SUBJECT: Forwards response to request for addl info re ceratin aspects of main steam line break protection circuitry.

Subject: Oconee Nuclear Station
Docket Nos. 50-269, -270, -287
Proposed Revision to Technical Specifications
Technical Specification Change # 95-03
Response to Request for Additional Information #2

RESPONSE TO REQUEST FOR ADDITIONAL INFORMATION

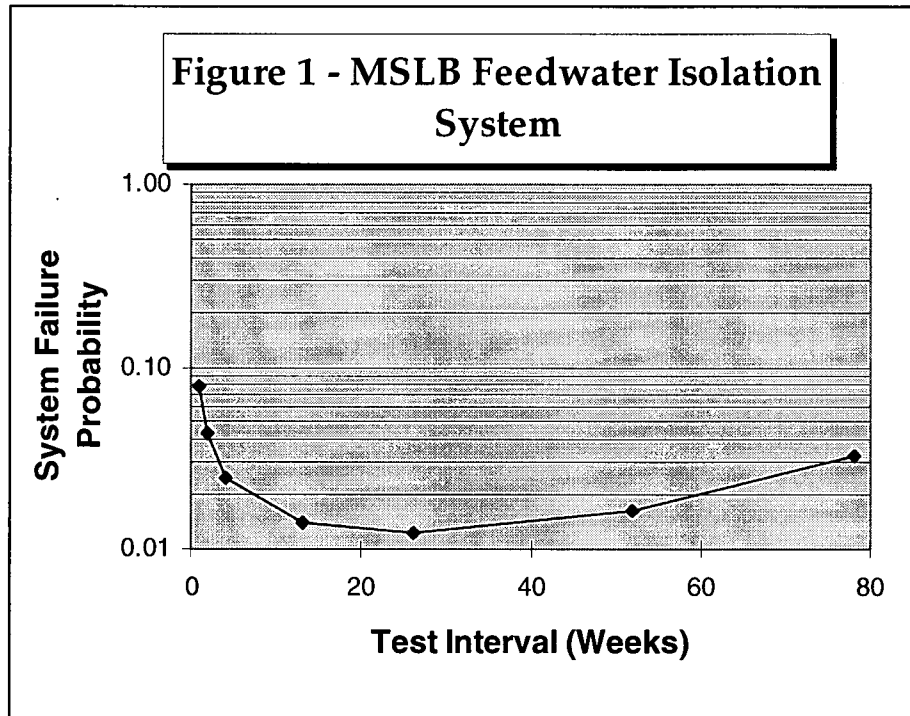
Attachment 3, page 13, para 2: Need supporting information from the study conducted to justify the claims made.

A study to determine the appropriate testing frequency for the circuit function verification test was conducted using standard PRA reliability analysis techniques. Specifically, this analysis entailed a fault tree analysis of functional failure of the system due to component failures, maintenance unavailability, or human error. Functional failure for this system is defined as a failure following a steam line break to isolate feedwater flow to the faulted steam generator. Seven different test cases were examined corresponding to seven different potential test intervals.

For each test case a different set of failure data was developed incorporating the maintenance unavailability and exposure time associated with the length of the test interval. The duration of each test is assumed to be 12 hours. The exposure time is simply one-half the mean time between tests, and is used to estimate the failure probability of certain components with time-dependent failure rates that can not be verified operable without testing. For components where a failure is indicated by alarms or can be detected by operators checking control board indications on "shift rounds", the mean unavailability was assumed to equal the hourly failure rate (/hr) times 18 hours (6 hours to discover plus 12 hours to repair). Table 1 below shows the corresponding maintenance unavailability and exposure time for each of the seven cases.

The analysis also considered common cause failure of similar redundant components and the potential for human errors that would render the system inoperable. The results shown in Figure 1 below show the competing influences of maintenance unavailability and system reliability.

Based on these results, the lowest "system" failure probability is achieved with a semi-annual test interval. While a semi-annual test frequency is optimal from a system reliability standpoint, a test frequency of every refueling outage provides a high level of reliability that is not significantly different than the semi-annual test frequency.
